**PLAN COMMISSION
MEETING**
October 3, 2022
4:00 PM

Administrative Staff Report

Ginzl Insurance

Theresa Cashman
 Site Plan Review
 3820 8th Street South
 September 26, 2022

C2	NEW SITE PLAN	DATE: 9.26.22	JOB NUMBER: 22007	DRWN. BY: R. BALKO	102 of 2
----	---------------	---------------	-------------------	--------------------	----------

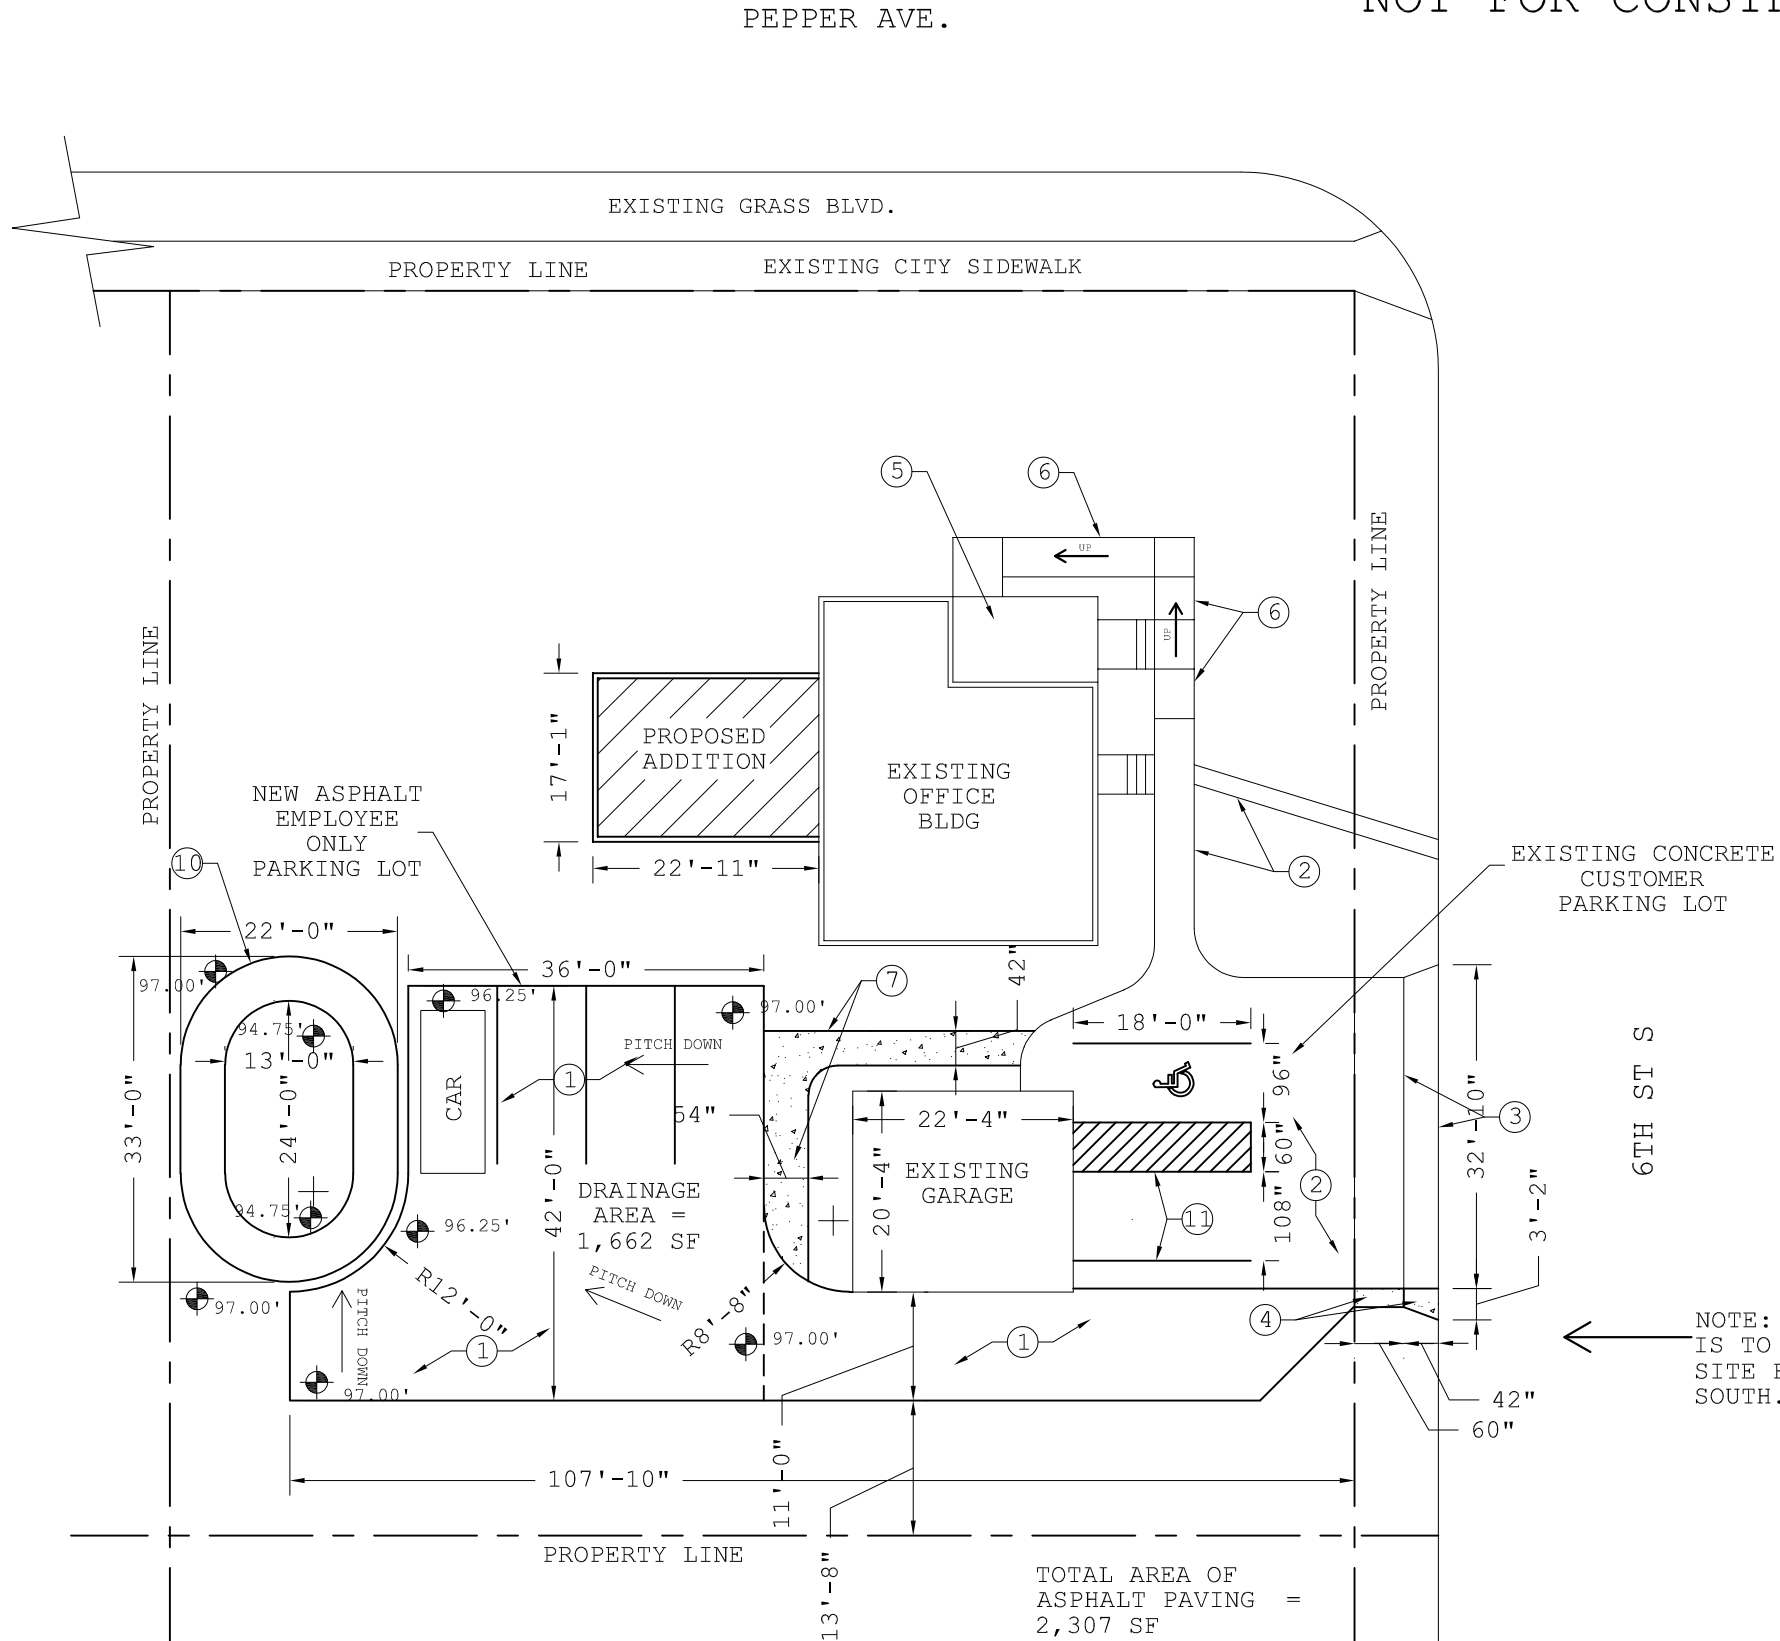
Findings: The development meets the parking requirements with a total of 7 parking spaces. One space would be required to be marked as an accessible parking space that meets ADA requirements. Of the 6 total spaces, 33% are located in front of the principal building (2 of 6 spaces). A total of 35% of parking in front of a principal building is permitted unless Plan Commission grants a special exception to allow up to 50%.

Based upon the current lot configuration, the only way to provide the needed parking to the rear of the principal building would be to remove the garage, change ingress/egress, or split parking as proposed. This property is surrounded by residential properties on all sides. To be more consistent with the residential nature of the neighborhood, it is more important to retain the garage and to keep a scale and style consistent with other residential properties. Therefore, staff supports the site plan with split parking, which helps to maintain the character of the area and better screen the proposed lot.

C3	LANDSCAPE PLAN	DATE: 9.26.22	JOB NUMBER: 22007
DRWN. BY: R. BALKO		DATE: 9.26.22	JOB NUMBER: 22007

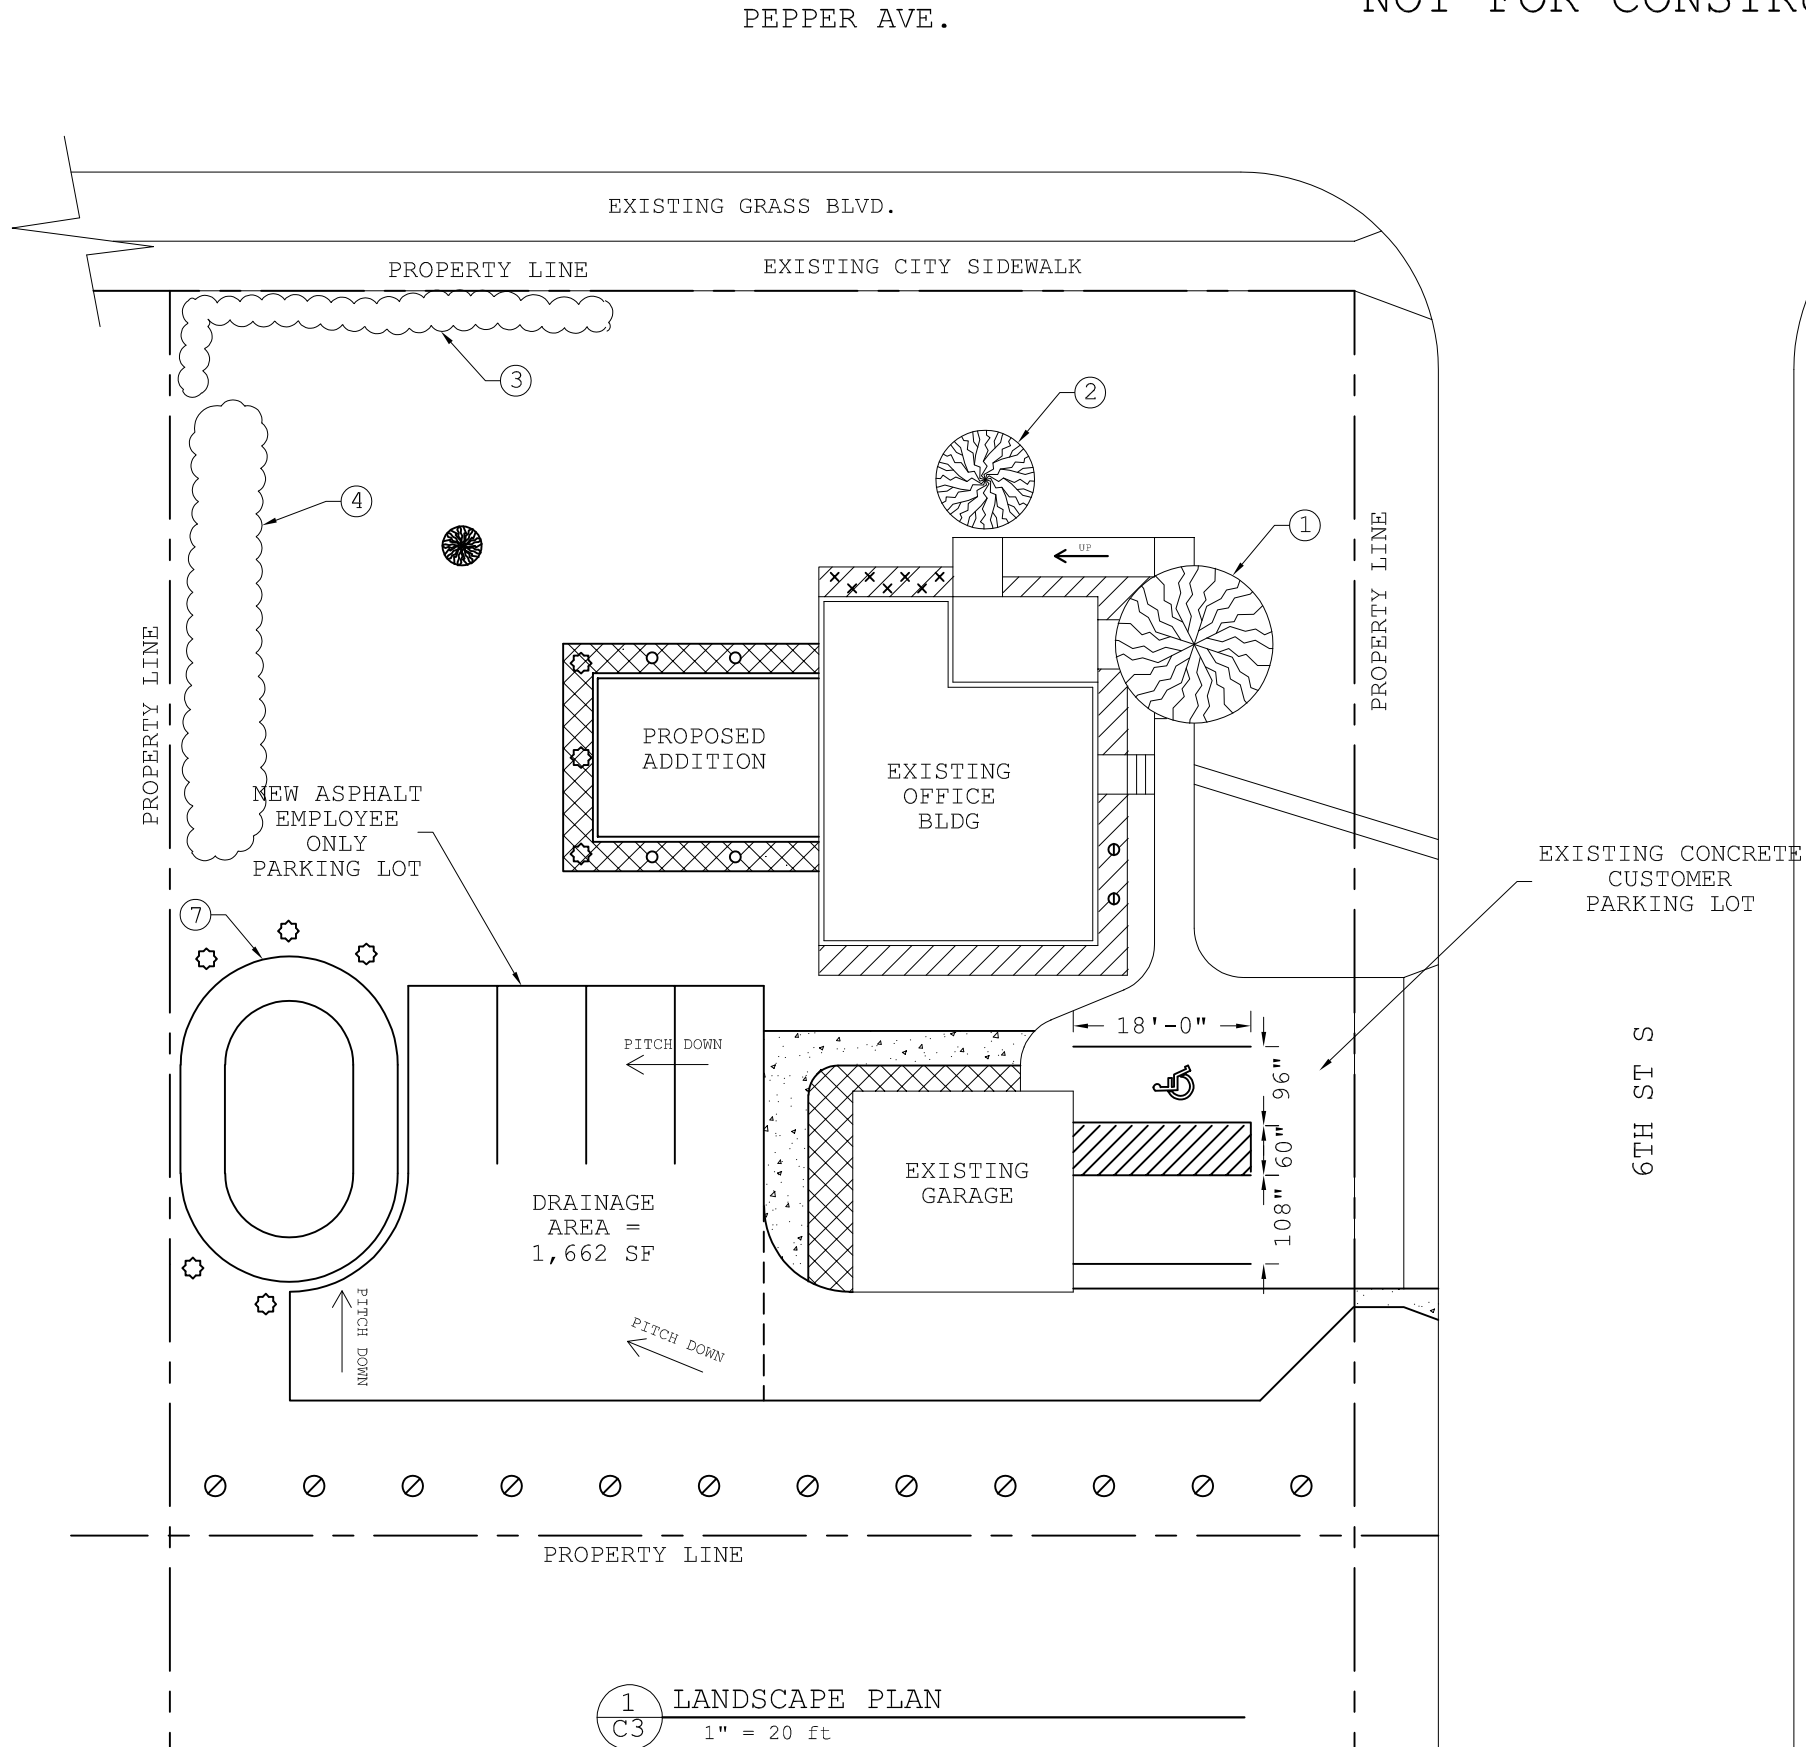
“(p) Screening. When a parking area with 5 or more parking spaces adjoins a property in a residential zoning district, a 4-foot screen (e.g., landscaping, berm, fence, or any combination) shall be installed and maintained.”

Findings: A landscaping plan has been submitted which meets the requirements, including landscaping in the bioretention area and along the adjacent property line. However, additional screening may be required along the west property line to meet the requirement above.
